ADDENDUM NO. 1

Job Name: Harrison County Jail MEP Renovation

Project Number: 800-71929

Date of Addendum: **12/5/2025**

6A FIRST FLOOR FIRE AND LIFE SAFETY PLAN
3/32" = 1'-0"

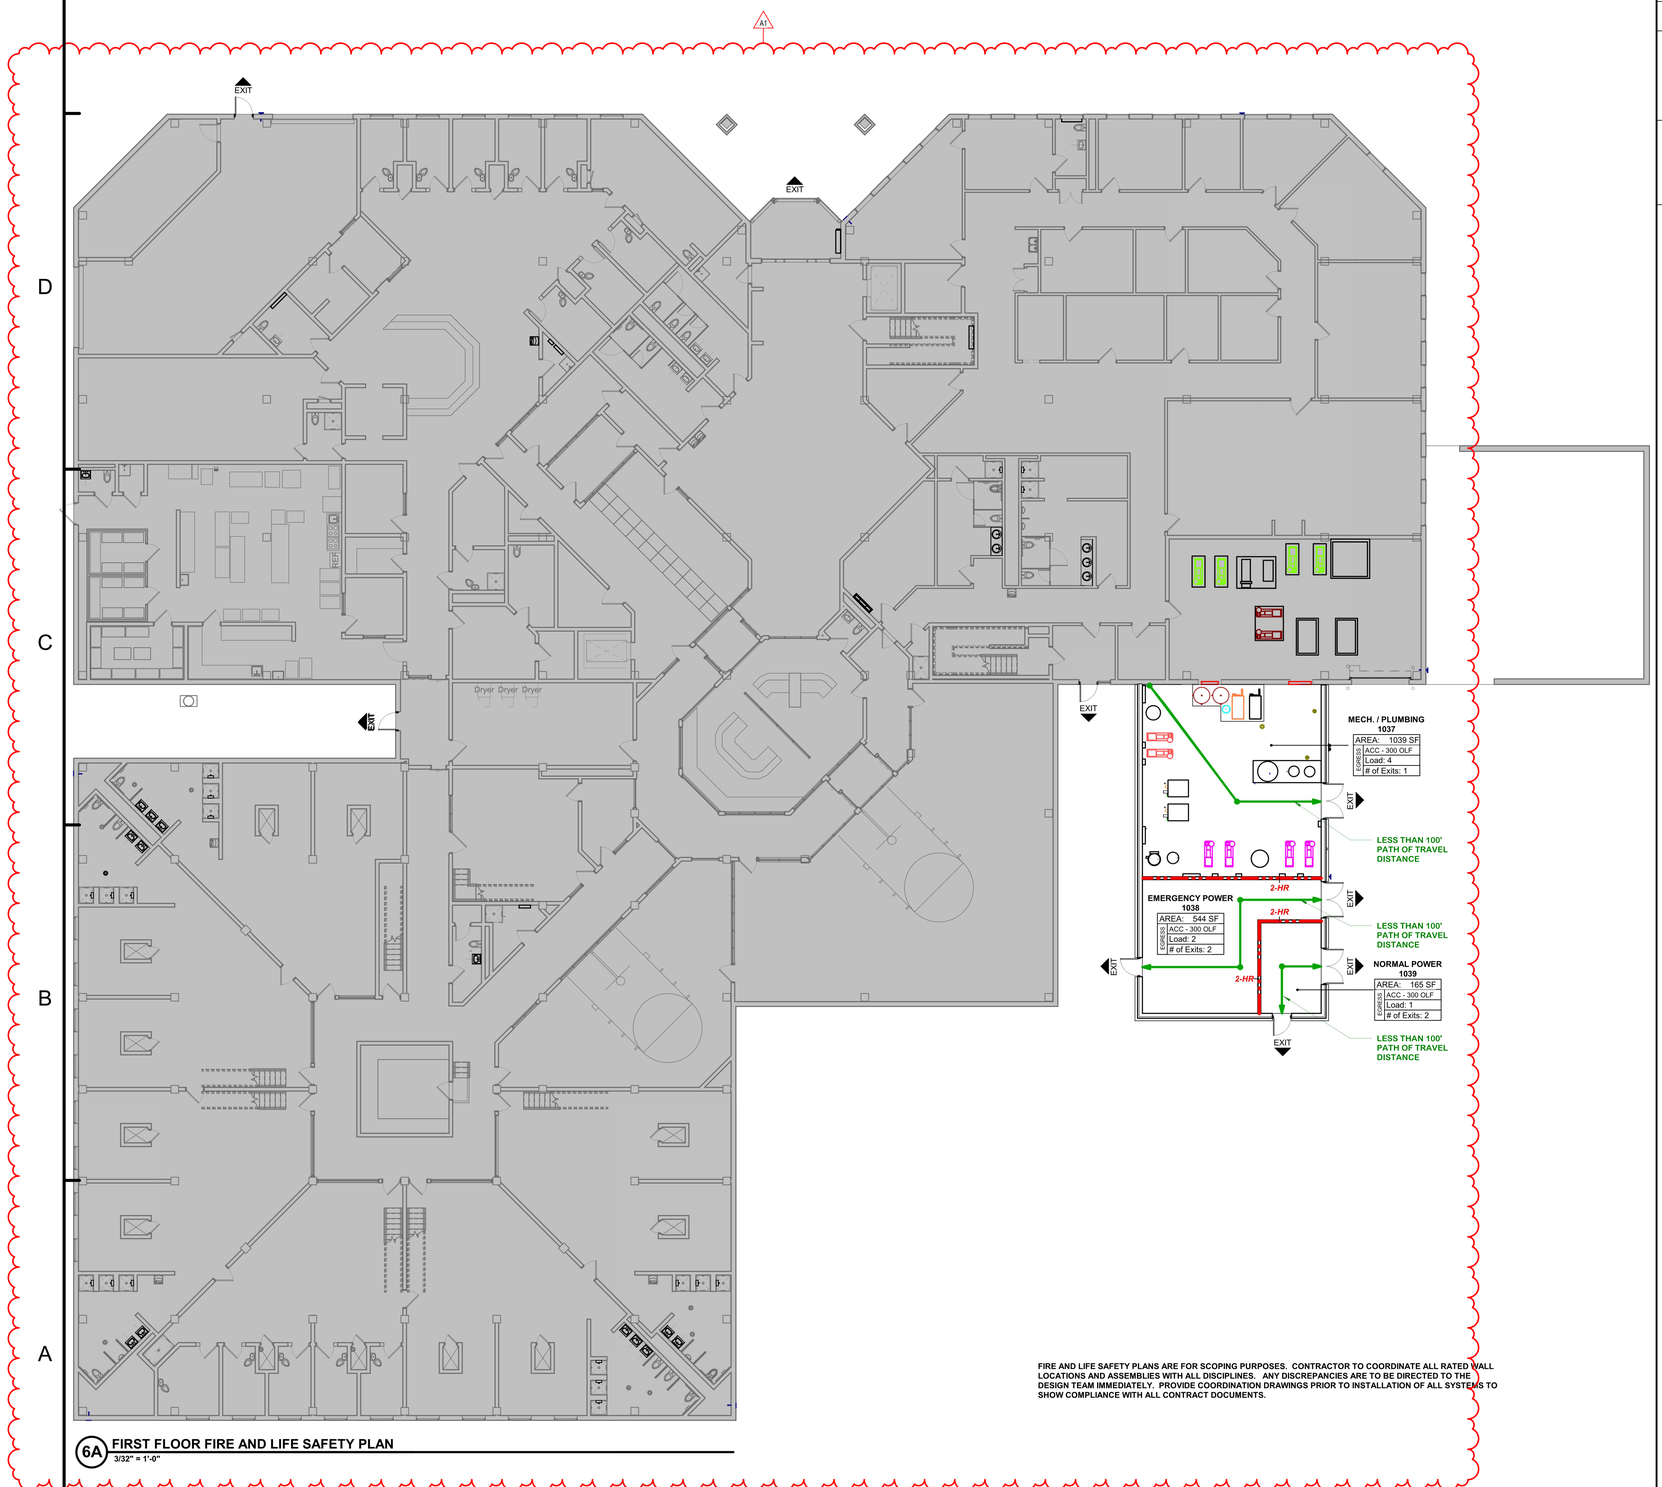
1. G -101 & G-102 – FIRST FLOOR FIRE AND LIFE SAFETY PLAN & SECOND FLOOR FIRE AND LIFE SAFETY PLAN
    a. **Clarifications:** Revised Code Summary and revised First Floor Fire and Life Safety Plan to graphically show the existing with more clarity.
2. PH-101, PH-201, & PH-203 – FIRST FLOOR PHASE 1, SECOND FLOOR PHASE 1, & SECOND FLOOR PHASE 3
    a. **Clarifications:** Revised spelling in Phasing Notes for A6 and E1. Phasing Notes P1, P2, P3 added. Plumbing and Fire Protection Remarks added.

2 SITE DEMOLITION PLAN
SCALE: 1"=20'

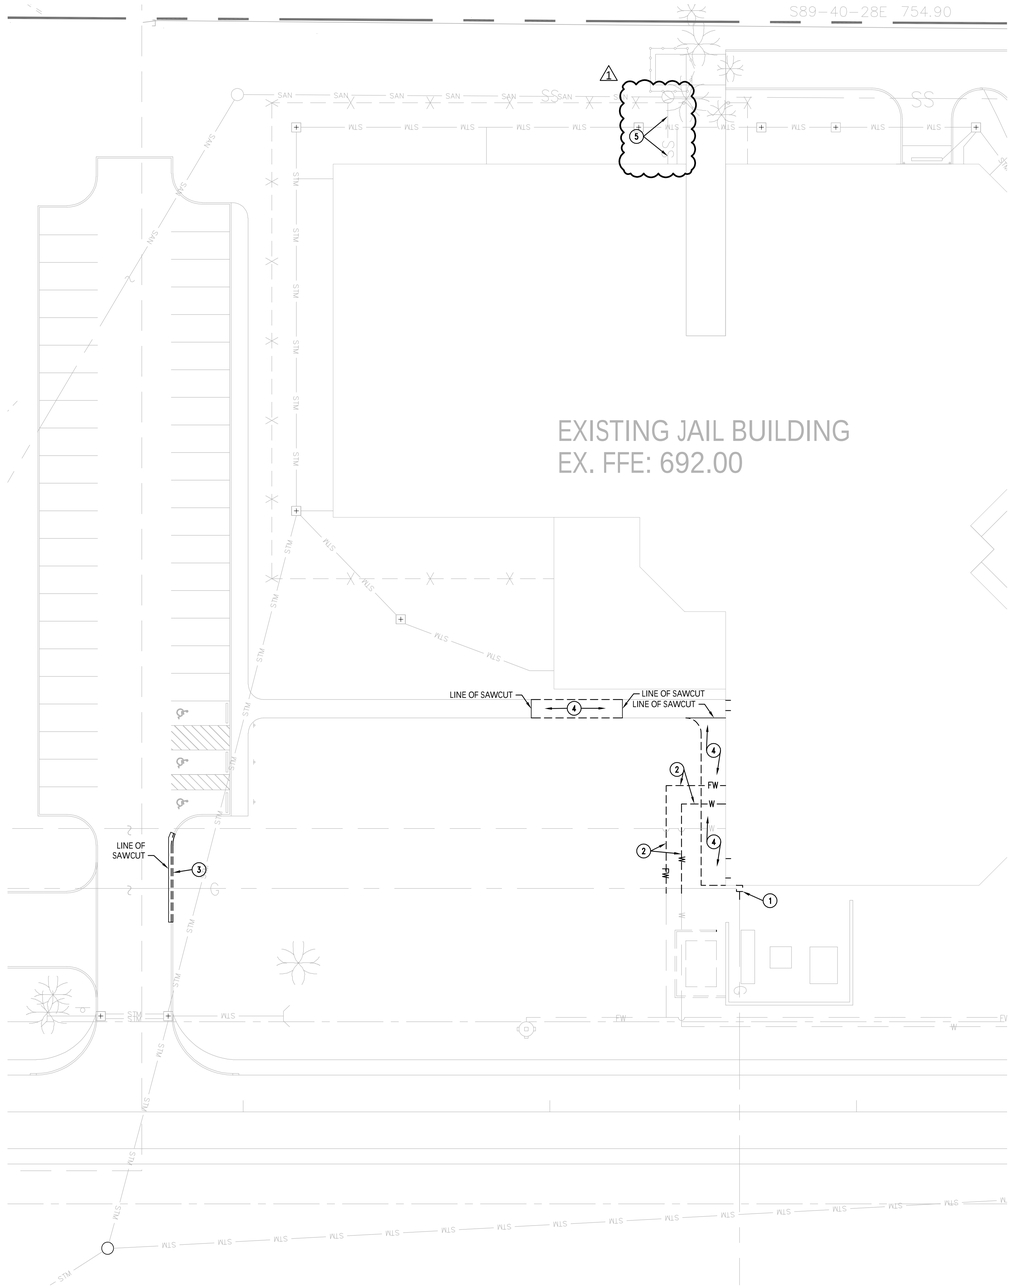
3. C100 – STORMWATER POLLUTION PREVENTION & SITE DEMOLITION PLAN
    a. Clarified notes for project phasing scope. Added section of broken sanitary pipe to be replaced.
4. C200 – SITE DEVELOPMENT PLAN
    a. Added section of broken sanitary pipe to be replaced.
